Transport
for NSW

TfNSW Reference: SYD17/00417/05
Council ref: PP2021/0001

**PLANNING PROPOSAL – 193-199 ROCKY POINT ROAD, 66-68 RAMSGATE ROAD
& 2-6 TARGO ROAD, RAMSGATE**

Attachment A: Detailed Comments on Planning Proposal – 193-199 Rocky Point Road, 66-68 Ramsgate Road & 2-6 Targo Road, Ramsgate

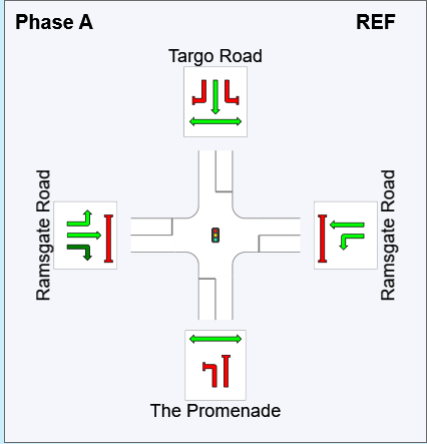
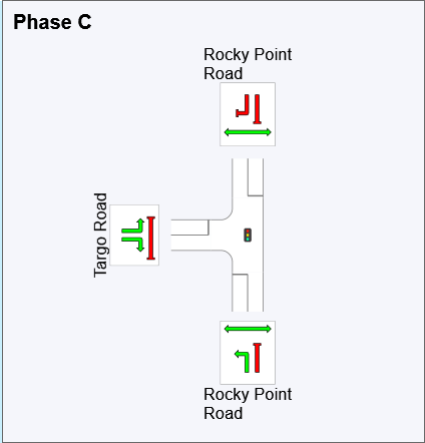
9	Phasing & Timing	<p>At the Ramsgate Road / Targo Road / The Promenade intersection, it appears the southbound through movement is occurring concurrently with a number of conflicting movements in phase A.</p>  <p>Similarly, phase C at the Rocky Point Road / Targo Road intersection has the northbound left turn occurring with the conflicting pedestrian movement.</p>	Medium
